DATE: 06.07.2018
TO: ProTrak
FROM: Mitesh Baxi
Traffic Engineering

■ **HURST HAMILTON PARKING LOTS [TRC Plan Review]**

↻ Initial Review Note ↻

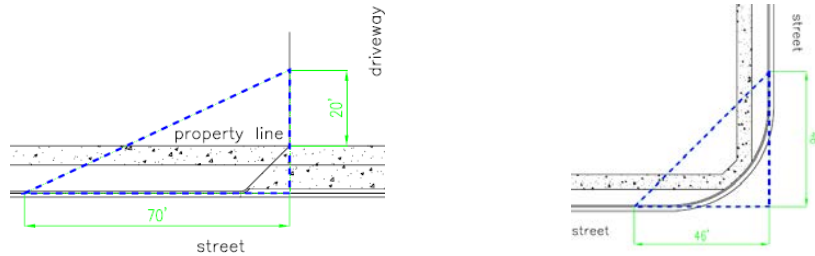
1. Driveways shall be City-standard ramp-type driveways. Show City standard detail(s) on plan. [\[SD 3-03.3 & 3-03.4 \(Vertical curb\) CofWTSSM\]](#). Where no curb exists in the vicinity, a flat slab type or a street type entrance may be allowed or required by the City Engineer. [\[page 7-9 CofWTSSM\]](#)
2. Provide sidewalk detail SD 3-10 on the plan.
3. Provide curbing detail SD 3-11 on the plan.
4. Site plan shows incorrect sight distance triangle for driveways. Show and apply the City’s 20’x70’ sight distance triangle at each driveway and the City’s 46’x46’ sight distance triangle at each street corner intersection on the site plan and landscaping plan. [\[Sec.18-529\(c\) \(3\) CofW LDC\]](#). Refer the below image.
